**SEQUOYAH NUCLEAR PLANT (SQN) - RESPONSE TO REQUEST FOR
ADDITIONAL INFORMATION (RAI) REGARDING TECHNICAL
SPECIFICATION (TS) CHANGE 00-14, "PRESSURE TEMPERATURE LIMITS
REPORT (PTLR) AND REQUEST FOR EXEMPTION FROM THE REQUIREMENTS
OF 10 CFR 50, APPENDIX G," (TAC NOS. MB6436 AND MB6437)**

SEQUOYAH NUCLEAR PLANT (SQN) RESPONSE TO REQUEST FOR ADDITIONAL INFORMATION (RAI)

TECHNICAL SPECIFICATION (TS) CHANGE NO. 00-14,
DOCKET NOS. 50-327 AND 50-328

Figure 1-1
Finite Element Model for Closure Head Region,
Sequoyah Units 1 and 2

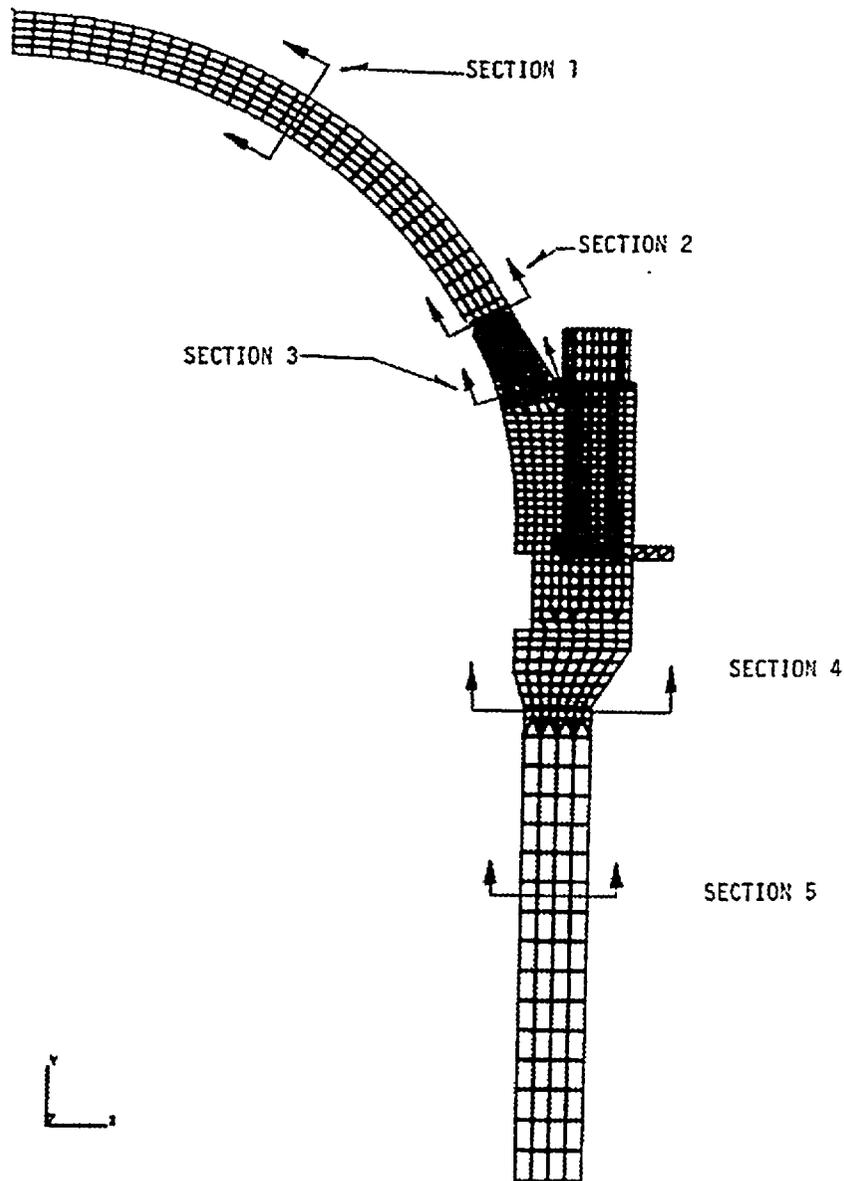
Regarding the discussion on page 4-1, "These results [the stresses for boltup and steady-state operation given in Table 4-1] were taken from a finite element analysis of the heatup/cooldown process, and the boltup was determined to be the most limiting time step for the entire heatup/cooldown transient."

Provide a summary which identifies how the finite element analysis (FEA) was performed, including important analysis variables (e.g., mesh size/element used, convergence criteria, thermal transient time step magnitude, boundary conditions, etc.). The level of detail provided should be such that the U.S. Nuclear Regulatory Commission (NRC) staff will have reasonable assurance regarding the acceptability of the licensee's FEA process and input variables. Provide stress analysis results consistent with the level of detail provided in Table 4-1) and through wall temperature distributions at twenty evenly distributed points along the most limiting heatup/cooldown transient which was analyzed.

The stress analysis was performed using an axisymmetric model shown in cross section in Figure 1-1, where the cross section of interest is highlighted as Section 3.

There are 54 studs that join the reactor vessel head to the closure flange. These studs are equally spaced around the vessel. Two-dimensional axisymmetric elements were used to model the closure flange region of the reactor vessel. There are a total of 996 elements and 1139 nodes in the model.

Physically, the reactor vessel shell will displace laterally, and the crown of the head does not displace laterally. To approximate this behavior, the bottom surface of the model in the shell region and the vertical surface of the model at the vessel crown were both assumed to be resting on rollers. This arrangement of restraint is assumed to correspond to the actual behavior of the vessel, and prevents any rigid body motion of the model.

the contained pressure operating loads. It is, therefore, assumed that during normal operating conditions, the mating surfaces will be pivoted, so as to reduce the gap and that the bearing load will be mostly carried near the pivot point. In keeping with this assumption, the head and shell are mechanically coupled only at one corner node nearest the studs, to allow completely free rotations.

Choosing to couple mechanically at only the pivot location, as discussed above, should tend to increase the bending stresses at all the selected Sections 1 through 5 shown on Figure 1-1. Mechanical coupling at more than one node, or all the nodes on the flange mating surface would have prevented free rotation of the flanges, and reduced the bending stresses.

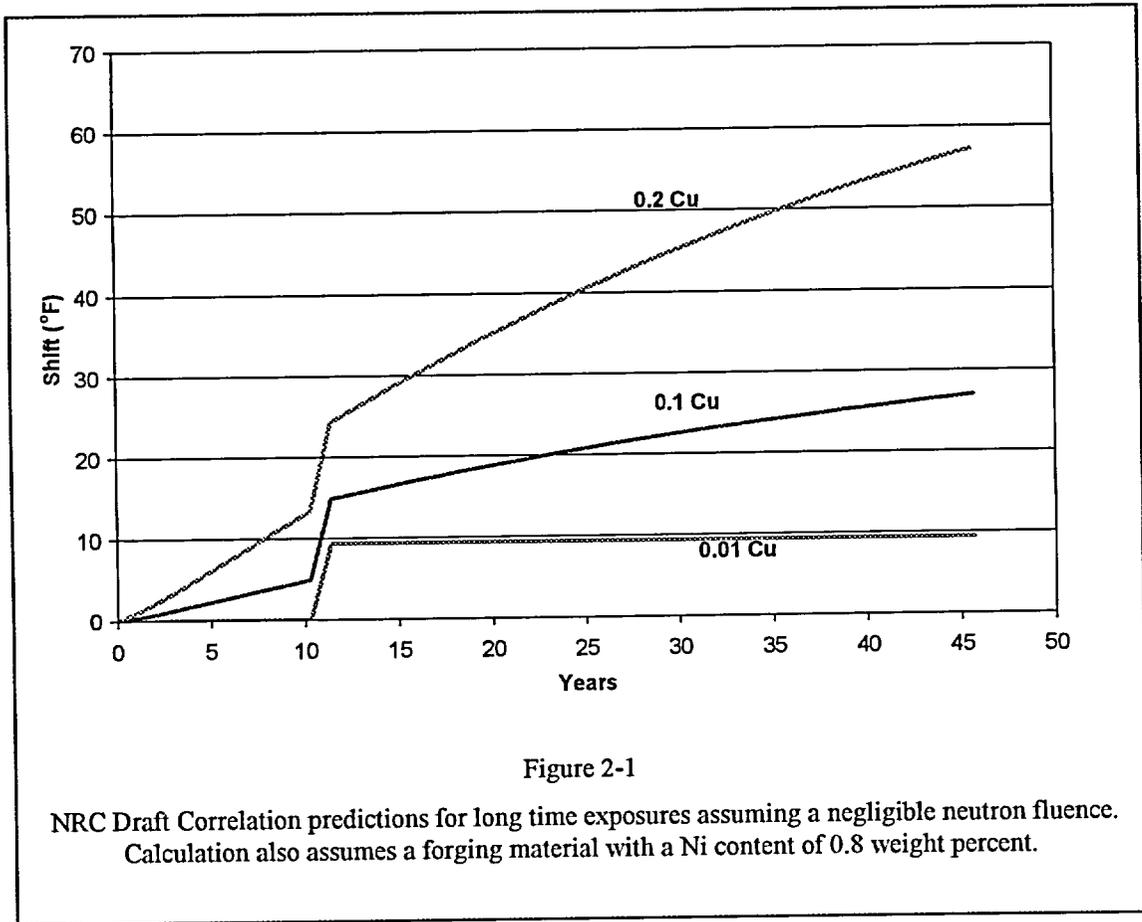
Regarding the information provided on page 4-2 on the effect of thermal aging:

- a. Provide the chemical composition (weight percent copper and nickel) of the Sequoyah, Unit 1 and Unit 2, reactor pressure vessel (RPV) closure head region materials.
- b. Recent work supported by the NRC's Office of Nuclear Regulatory Research has led to the development of new RPV embrittlement models which incorporate terms that have the effect of a "thermal aging" (time-at-temperature) function (original work documented in NUREG/CR-6551, "Improved Embrittlement Correlations for Reactor Pressure Vessel Steel"). The most recent version of the proposed embrittlement model is included below, along with suggested input value definitions:

Making the conservative assumption that the embrittlement model equation may be directly applied to the evaluation of thermal aging effects for RPV flange materials (with the effective neutron fluence set to a nominally small value), evaluate what the predicted shift in RT_{ndt} would be for the Sequoyah, Unit 1 and Unit 2, RPV closure head region materials, and provide the predicted final RT_{ndt} values for these materials at the current end of license condition for the units.

Assess what impact these values would have on the conclusions drawn in WCAP-15984 and the licensee's exemption request.

The estimates for the Sequoyah Unit 1 and 2 flange chemistries have been compiled assuming a forging material with a Ni content of 0.8 weight percent and a fluence of 10^{14} n/cm^2 . The results of

this analysis are summarized in Figure 2-1. Three different possible Cu contents are illustrated. No specific copper contents are available for the Sequoyah units, but the 0.2 Cu level exceeds the level normally expected in RPV Forgings.

From this result, it can be seen that the effect of thermal aging on the head material is small.
